ANTI-VIBRATION KIT

NOTE: This kit is intended for machines manufactured prior to 10/27/99.

#609212 KIT CONTENTS

Fig. 1 (Before)

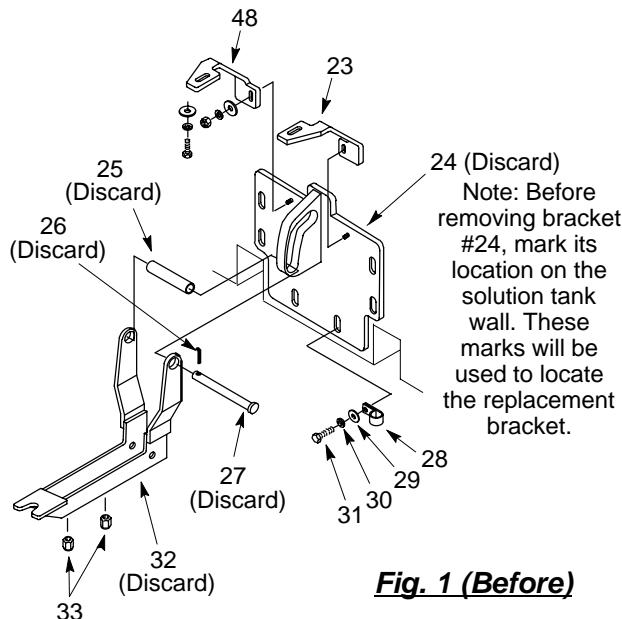
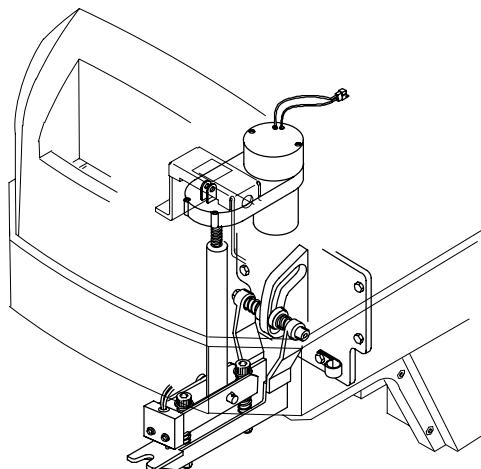
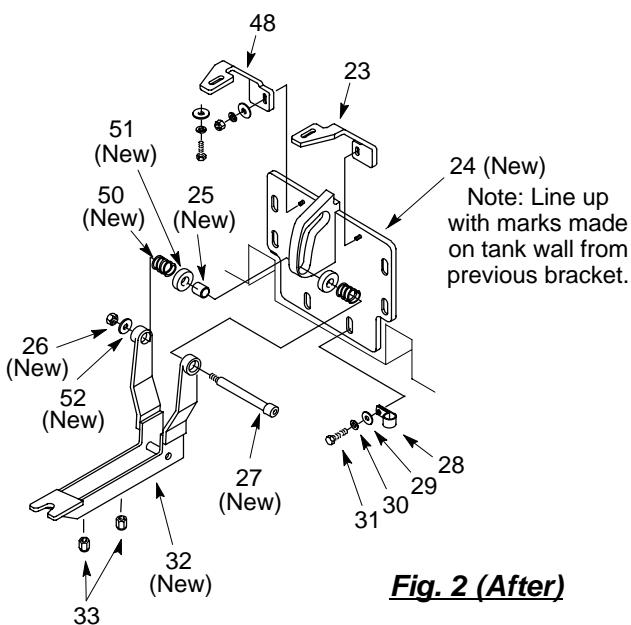
1. Remove scrubhead from machine per operations manual.
2. Remove (2) nuts #33 (fig. 1).
3. Remove brackets #23 & #48 (fig. 1).
Brackets are tied to wire harness and will hang loose.
4. Before removing bracket #24, use a marker or scribe to mark its location on the solution tank wall. Mark both sides of the bracket. These marks will be used to assure proper alignment of the new bracket (fig. 1).
5. Remove and discard bracket assembly #24/#32 by removing (6) screws #31 (fig. 1).
6. Mount new bracket #24 to tank. Be sure to line up with the marks made on the side of the tank from the previous bracket (fig. 2).
7. Reinstall brackets #23 & #48 (fig 2).
8. Install new bracket #32 and related hardware (fig. 2).
9. Reinstall (2) nuts #33 (fig 2).
10. Reinstall scrubhead to machine.
